TECHNICAL NOTE

DATE:	08 August 2024	CONFIDENTIALITY:	Confidential
SUBJECT:	WBLR Phase 3 area reduction for Phase 1 drainage (WBLR-WSP-HDG-00-AN-C-0174 S3-P01)		
PROJECT:	ED/100377 WBLR	AUTHOR:	Alexander Strickland
CHECKED:	Andrew Burrows	APPROVED:	Andrew Burrows

INTRODUCTION

Figure 1 Catchment area markups in query

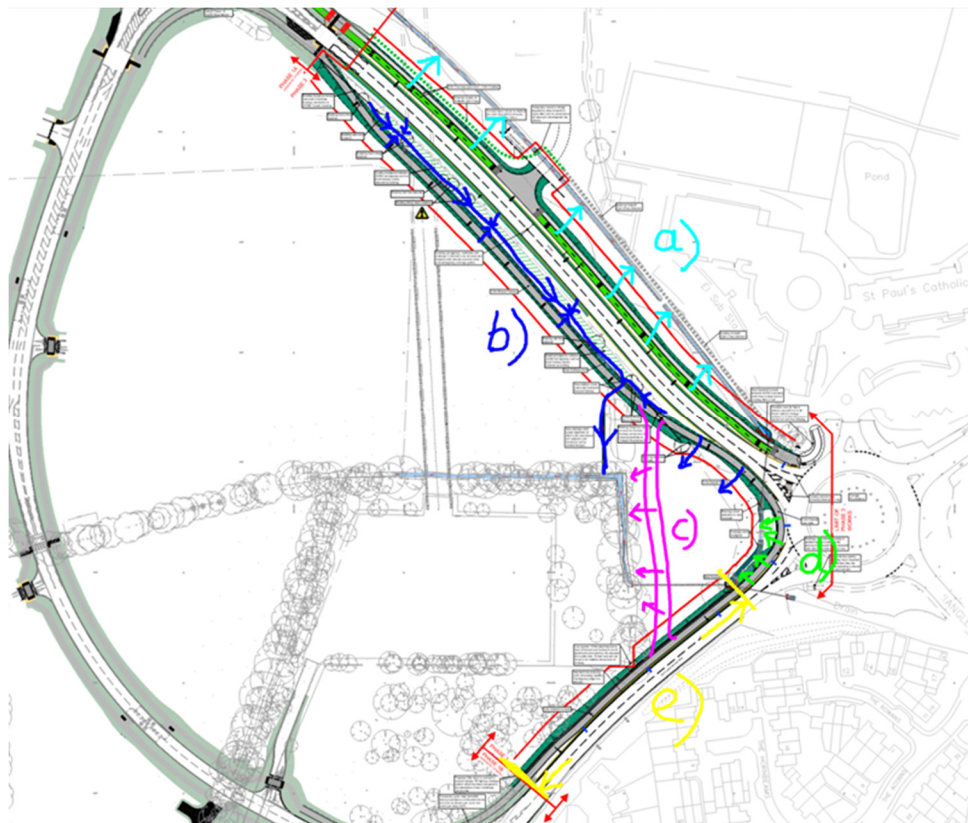
WSP has received a query from JCE following changes to the catchment areas in Phase 3 that are to drain into the Phase 1 network. The proposed change is that only area e), shown in figure 1 (in yellow), will now drain into the Phase 1 southern network. The following component areas were provided for the revised area:

The query received asked WSP to review the currently installed Phase 1 hydrobrakes due to the contributing catchment area being reduced and confirm if the southern basin hydrobrake needed re-specifying, and swapping out at some point in the future.

The contributing area of Phase 3 only drains into the South network for Phase 1, the North basin hydrobrake is therefore unaffected. This review has concluded that the South basin hydrobrake will need to be replaced due to the changes to the Phase 3 areas. The design flow rate for the network outfalls is based on Qbar (5.8l/s/Ha) multiplied by the catchment area.

Figure 2 South basin hydrobrake flow to depth curve

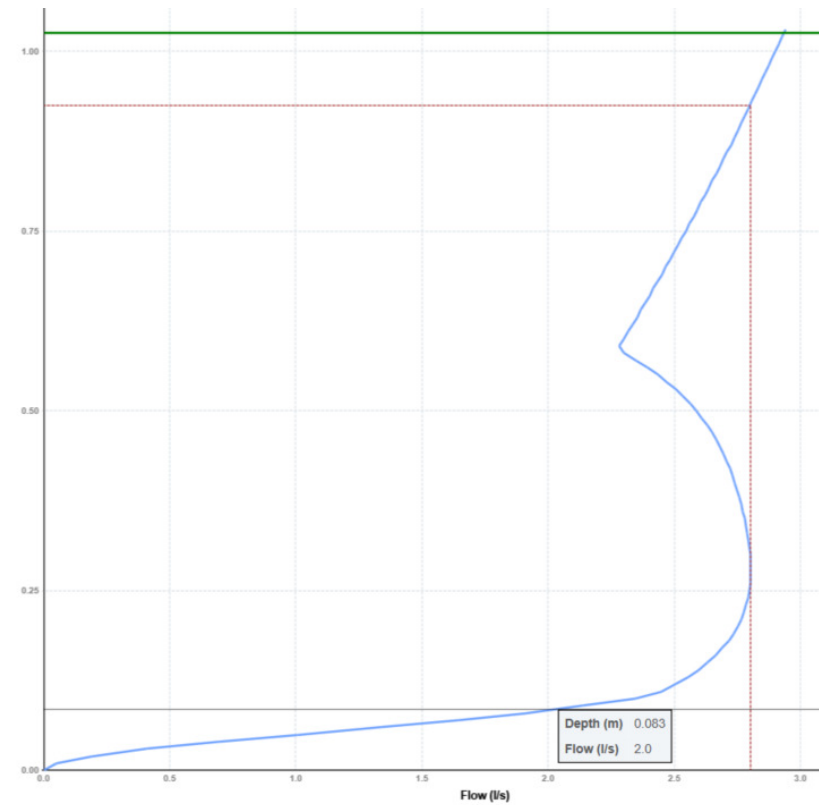
The current design flow rate is 2.8l/s for a total catchment area of 0.475Ha. As the catchment area is being reduced from 0.475 to 0.402Ha the current hydrobrake would be unacceptable. Figure 2 shows the flow to depth curve for the basin's hydrobrake. It demonstrates two points that the design flow rate of 2.8l/s will be reached. The second is at the design depth which will not be reached as the contributing area has been reduced. The first is at a depth of 0.275m just before the vortex is formed.

The first exceedance of the Phase 1 only permitted discharge (2.0l/s) is however at a much shallower depth (0.083m), which will be reached even during frequent, low return period, storm events.

Due to the frequency that the permitted discharge rate of 2.0l/s will be exceeded if the current hydrobrake is retained it is recommended that the hydrobrake is changed during the Phase 1 works.

Therefore, whilst the southern basin hydrobrake will need to be swapped out in Phase 1, a 2.0l/s hydrobrake will also be sufficient for the final arrangement with Phase 3 connected.
